CLIENT  
MAB  
Lot G,  
Docklands, VIC, 3008

## DELEGATE REPORT MINISTERIAL PLANNING REFERRAL

<b>Application number:</b>	TPM-2022-3
<b>DELWP Application number:</b>	PA2101471
<b>Applicant / Owner / Architect:</b>	MAB Corporation / Development Victoria / Freadman White Architects
<b>Address:</b>	473-505 Docklands Drive, Docklands (Lot G)
<b>Proposal:</b>	Construction of a multi-storey apartment development
<b>Cost of works:</b>	\$80,000,000
<b>Date received:</b>	18 January 2022
<b>Responsible officer:</b>	Lachlan Orr, Principal Urban Planner

Figure 8: Podium Heights and Setbacks (Development Plan)

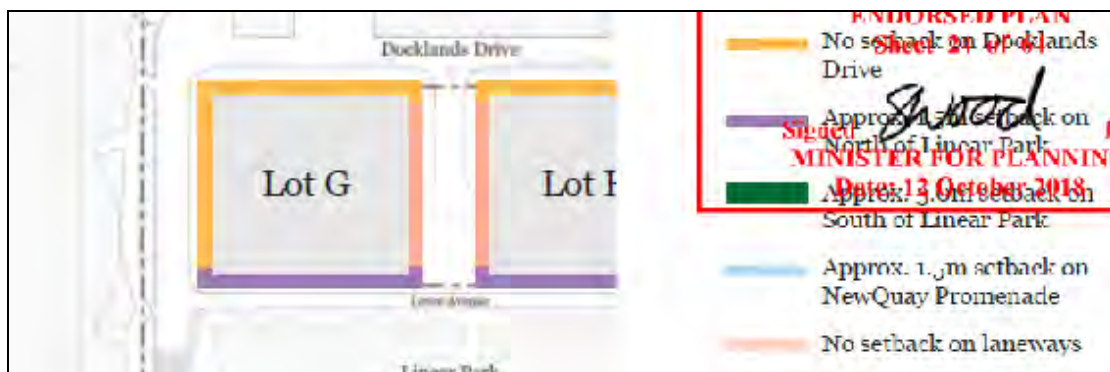
- The podium is largely constructed to the north, east and west boundaries over five to six levels, which is generally consistent with the Development Plan.

- Varied setbacks of between 1 to 4.5 metres are provided over the ground and first floor levels around individual dwellings and their front courtyards and terraces. While exceeding the zero setback under the Development Plan, these larger setbacks do not undermine the overall presentation of the solid podium form and punctuate the individual dwellings by establishing a human scale at street level.

- The Development Plan indicates a 1.5 metre setback to be provided to the south facing the linear park. The proposal provides varied setbacks of between 1 to 4.5 metres. Similar to the other interfaces, the varied setbacks and partial encroachments into the 1.5 metre setback are considered appropriate when considered in the context of the development as a whole. The individual dwellings are provided with landscaped terraces and legible entry points along the lower levels of this interface, while the terraces and balconies above provide visual interest and passive surveillance of the public realm.

Figure 9: Maximum Building Heights (Development Plan)

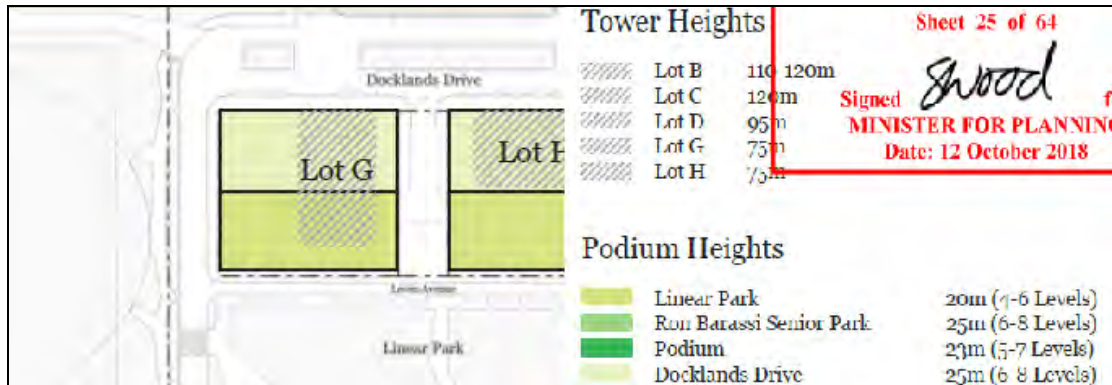
- The Development Plan provides for a maximum podium height of up to 20 metres (4-6 levels) to the linear park and 25 metres (6-8 levels) to Docklands Drive and Ron Barassi Senior Park.
- The podium proposes a height of 21.4 m (6 levels) which is considered generally in accordance with the height sought by the Development Plan. While there is a

slight exceedance of the 20 metre podium height to the linear park, this would enable a legible reading of the podium form and would not unacceptably impact on the amenity of the future public realm or adjoining developments.

- The Development Plan indicates a maximum tower height of 75 metres. The proposed tower is 75.57 m in height, which is considered generally in accordance with the Development Plan. The encroachment of 0.57 metres is considered negligible and would not contribute to a visually dominant building form, or unreasonable additional overshadowing of the public realm.

Figure 11: Proposed tower design plan and diagrams (Applicant)

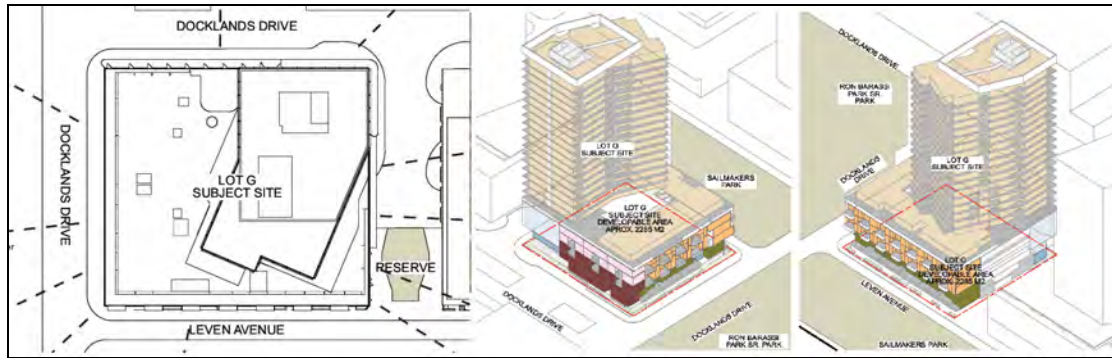
- The Development Plan provides two indicative options for tower form, envelope and general siting which are shown below and include provision for up to 50% of the tower to be constructed along the boundary with Docklands Drive. The proposed tower has an angled envelope, which is partially constructed along the northern boundary for a length of 24.5 metres (49%) and eastern boundary for a length of 18 metres (39%).

- While varying the indicative envelopes, the proposed tower is considered to be generally in accordance with the Development Plan and consistent with the relevant principles for Lot G. The angled form of the envelope and the varied setbacks provided achieve a visually interesting and articulated form, which references the approved Lot H building in what would form a pair as they present to the wider context. The tower envelope also achieves improved views of the water and public open spaces as sought by the Development Plan, while avoiding unreasonable overshadowing of existing and future public open spaces as discussed further below.

Figure 14: Interfaces (Development Plan)

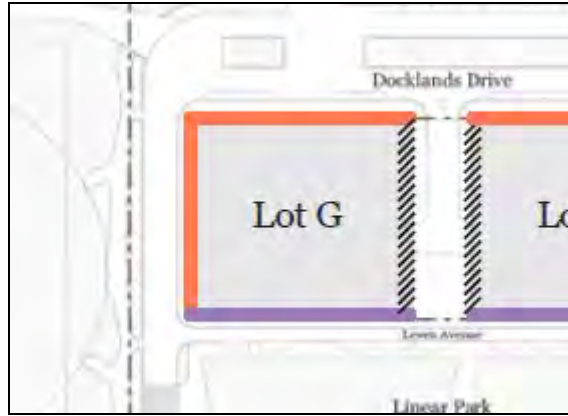
- The linear park interface (purple) is consistent with the Development Plan, with setbacks provided to accommodate articulated landscape zones around individual dwelling entries. The design of fencing and terracing achieves a clear delineation between the public and private realm, while maintaining adequate passive surveillance of the future road and linear park. The dwelling layout and punctuated facades achieve the desired townhouse presentation to this interface.

- The northern and western interfaces (orange) is consistent with the Development Plan design principles for Docklands Drive. Individual facades are provided to the boundary with direct entries to dwellings, with flexible mixed use or office spaces along the northern elevation and elevated residential spaces along the western elevation. Awnings are provided to each interface.

- Services are predominately located along the eastern interface (hatched black) to the future service road, consistent with the Development Plan.

Figure 23: Tower apartment balcony variation (Applicant)

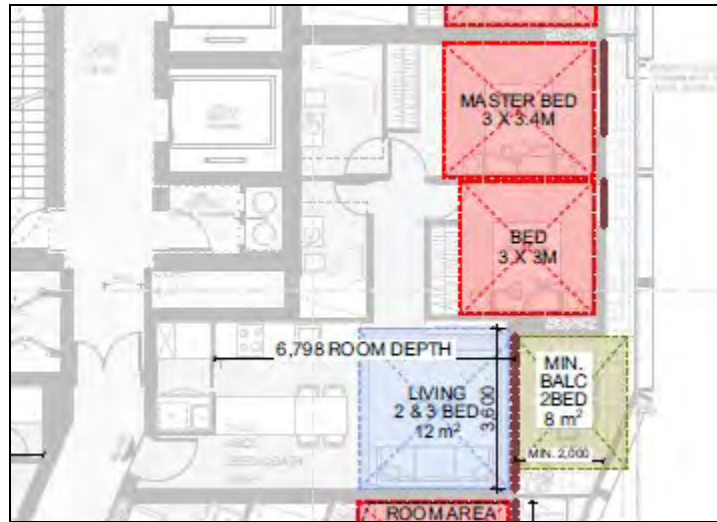
While the apartments are provided with over 8 square metres of private open space, the angle of the balcony encroaches into the edge of the area which is provided with the required minimum internal dimension of 2 metres. The minor variation of approximately 0.8 square metres to one area of these balconies is considered acceptable, as it would not unreasonably impact on the function and recreational

capacity for future residents. The balconies are supplemented by their narrower extension along the bedrooms.

Figure 24: Tower apartment master bedroom variation (Applicant)

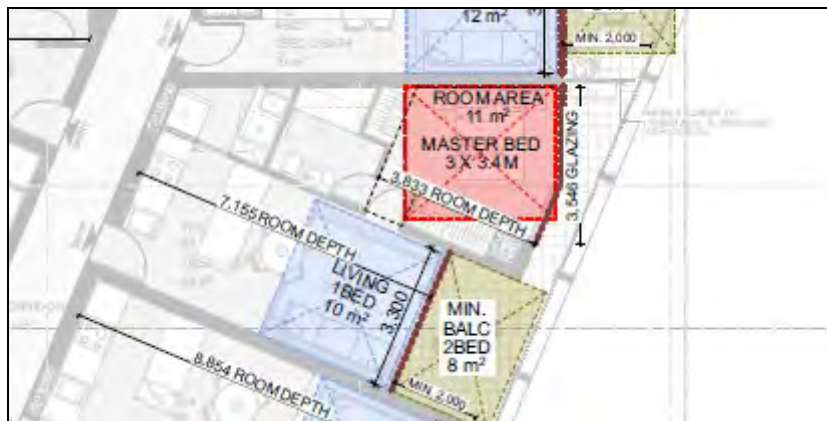
The proposal provides compliant bedroom and living area dimensions as required by Standard D25 however, similar to the variation for Standard D19, seeks variations in relation to the apartments located on the elbow of the tower. Due to the angled alignment the master bedrooms of one apartment on each level of the tower falls short of the minimum 3.4 metre dimension at its south-eastern corner (see below), at a length of approximately 3.25 metres.

A variation is considered acceptable for this minor shortfall, which is not considered to unreasonably impede on the function and amenity of the bedrooms. The layout and dimensions of the bedroom are ample for a bed, storage and circulation space. The apartments are otherwise provided with compliant living areas and private open space.

Figure 25: Podium apartment room depth variation (Applicant)

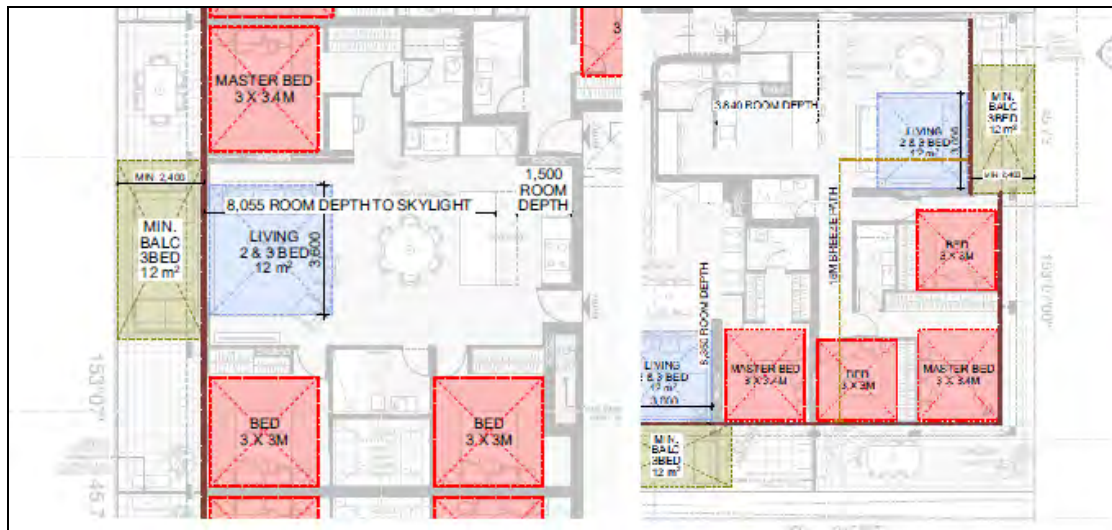
The depth of single aspect living rooms complies with Standard D26 with the exception of two apartments located in the podium. These living areas have depths exceeding 9 metres from the window between approximately 9.2 to 9.5 metres.

While these living areas exceed the maximum depth under the standard, they form part of an apartment layout which is generous overall with large floor plates and balcony areas which greatly exceed the minimum area required by Standard D19. The living rooms are also provided with skylights or glass brick walls onto the communal open space area to enhance access to daylight in these areas. A variation is therefore considered acceptable.
